## **Wylfa Newydd Project**

**6.3.25 ES Volume C - Road traffic-related effects (project-wide) App C2-4 - DCO TA Appendix K - Road Safety Audits**

**Logistics Centre External Layout**

**Stage 1 Road Safety Audit**

**Figure A.1 – Appendix A. Site location plan indicating the location of the problems.**

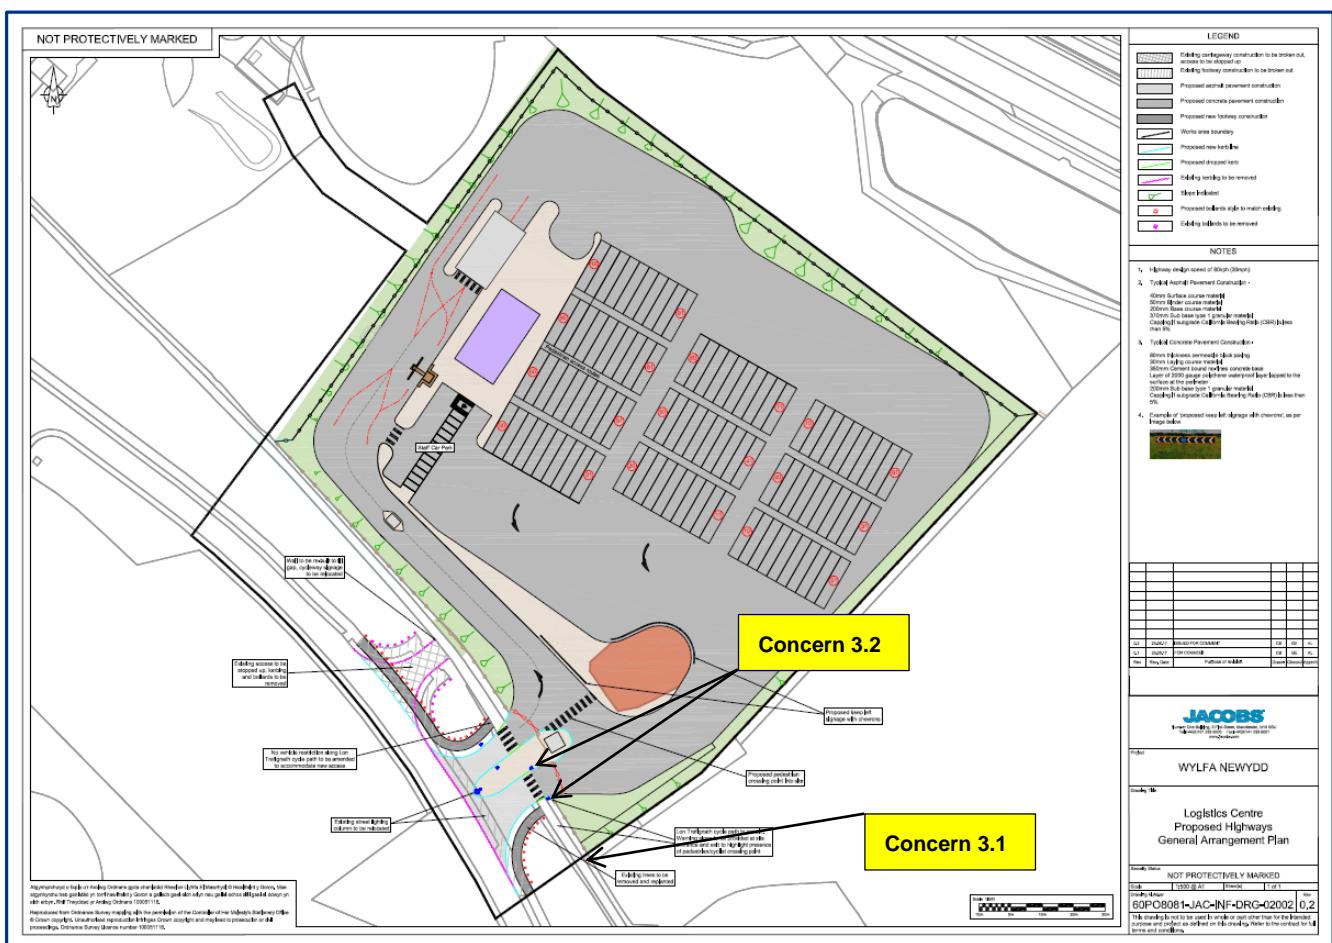
It is proposed to install a gated entrance to an access track leading to another gate at the north eastern corner of the facility. This gate would lead onto the Lon Trefignath cycleway. The reason for this access track is not indicated on the drawing. If vehicular access is required this proposed entrance would conflict with users of the cycleway, as a designated access off the highway has not been proposed.

It is suggested that to aid locating the site extents, a location plan is inserted into the drawing at detailed design stage to confirm the exact location of the Logistics Centre.

**Figure 3.1 - Image showing that there is a 'crest' in the carriageway (A5) on the westbound approach to the proposed traffic signals.**

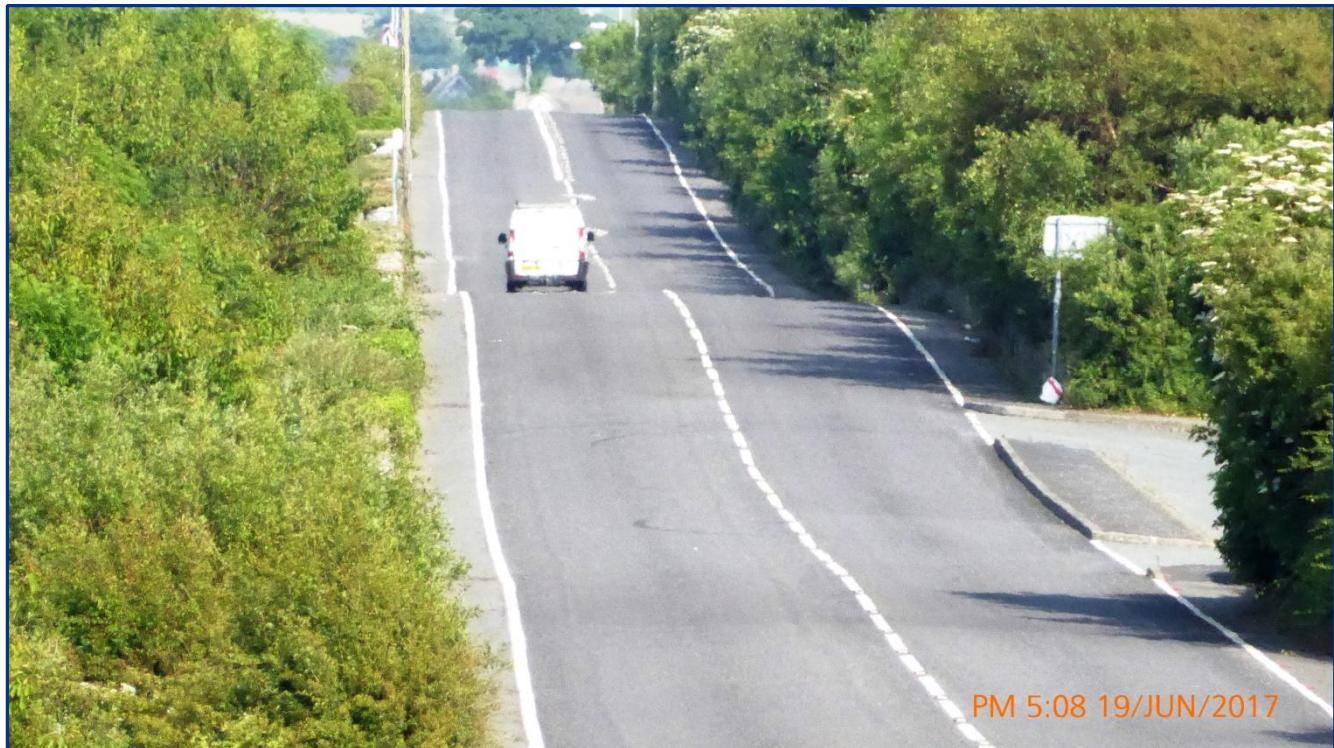
The A5 at this location is very straight and it is anticipated that vehicle speeds approaching the proposed traffic signal junction could be in excess of the speed limit. Additionally, there is a crest on the westbound approach just ahead of the proposed location of the stop line. This could result in drivers colliding with the rear of stationary traffic resulting in 'rear-end' shunt type collisions. **See Figure 3.1 below.**

We are not convinced that this is an issue. Figure 3.1 looks very misleading when you compare it to standing at the point where the junction will be located. Forward visibility exercise has been undertaken by Jacobs highways team. Further assessment can be undertaken to confirm if high-mast traffic poles are required.
